TOWN OF STRATFORD
COMMUNITY CAMPUS SITE SERVICING

CONTRACT NO. 222617.00

ADDENDUM NO. 3

April 11, 2023

Drawing C11 – Plan & Profile Street A - Sta 0+220 to 0+ 300

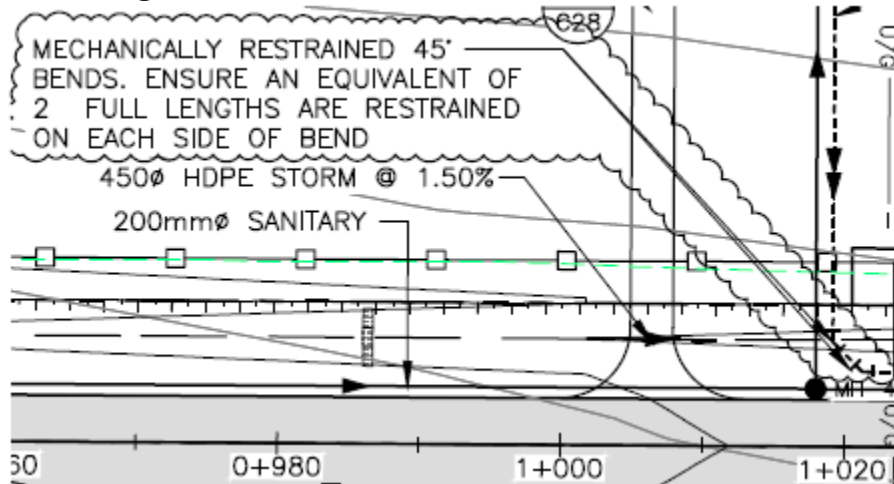
1. Delete note 2 & replace with the following:

2. Add new note 3:

- 3. Reworked till is considered native till (see Geotechnical report). The entire layer of reworked till is not required to be removed. Remove root mat and brown silty/ clayey sand (topsoil) layer.

- 2. Contractor shall install a 6.1m wide temporary access road to the future high school property by stripping topsoil to native till and replacing with select borrow to the original grade and such that positive drainage is provided. Upon completion of construction the temporary access road shall be removed and reinstated to the original condition.

Drawing C15 - Plan & profile Street A -Sta 1+260 to 1+580

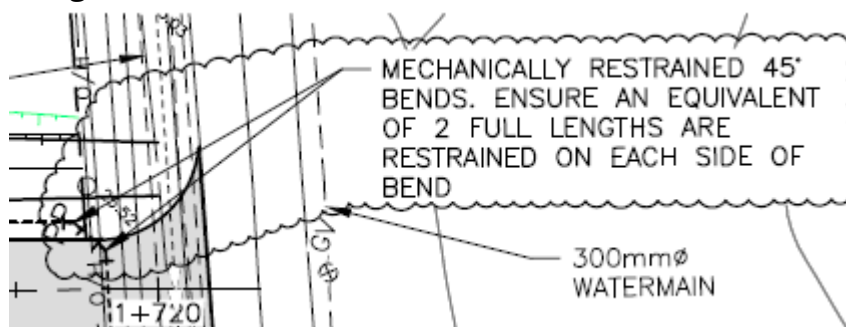
1. Add new legend item:

● → POWER POLE & GUY (PR.)

Drawing C16 - Plan & profile Street A -Sta 1+580 to 1+730

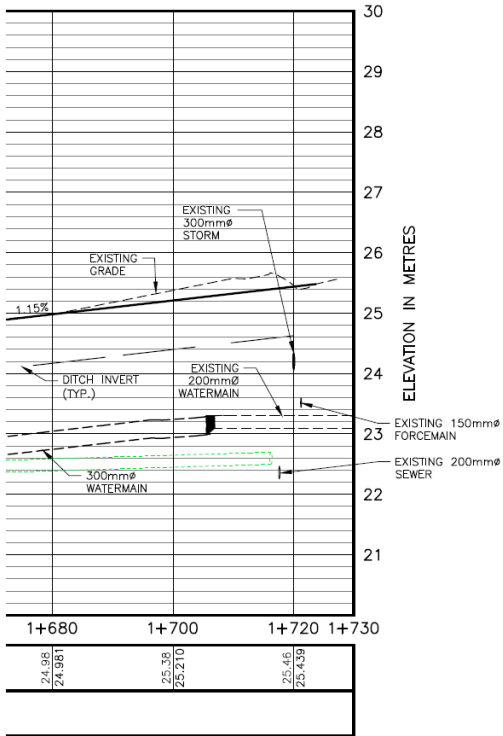
2. Delete 90-degree bend on forcemain and replace with 2 mechanically restrained 45-degree bends as shown below.

3. Add existing Sanitary, Forcemain and Storm Sewer crossings to profile as shown below.

Drawing C18- Plan & Profile Lift Station Sewer - Sta 3+000 to 3+150

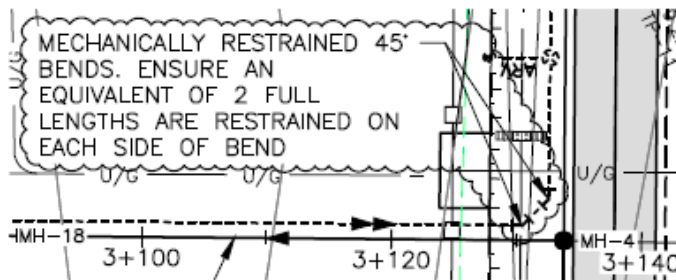
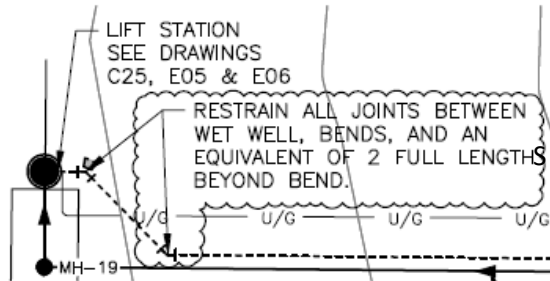
- 1. Increase Forcemain depth to provide 1.8m cover below existing grade between STA 3+017 to 3+123.**
- 2. Delete 90-degree bend on forcemain and replace with 2 mechanically restrained 45-degree bends as shown below.**

3. Delete note regarding thrust restrains on fittings from lift station and replace as shown below.

Drawing C19 – Plan & Profile Hollis Avenue

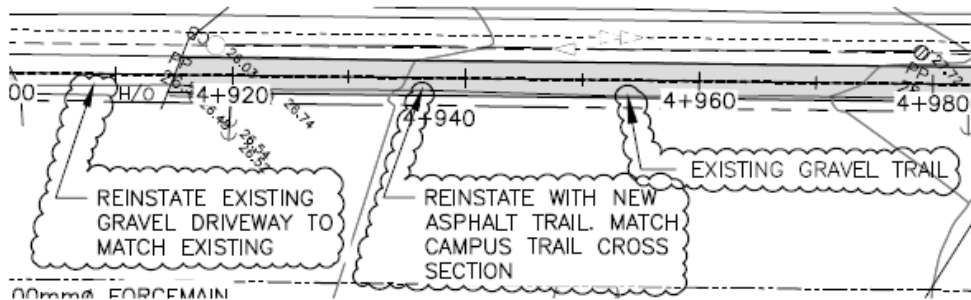
1. Add new callout to existing MH at Sta 4+845 “Remove existing frame, grade rings and sections as required to install new floating frame & cover”
2. Add new callout at Sta 4+908 “Reinstate existing gravel driveway to match existing”
3. Delete callout at Sta 4+935 and replace with “Reinstate with new asphalt trail. Match campus trail cross section”
4. Add new callout at Sta 4+955 “Exiting gravel trail”
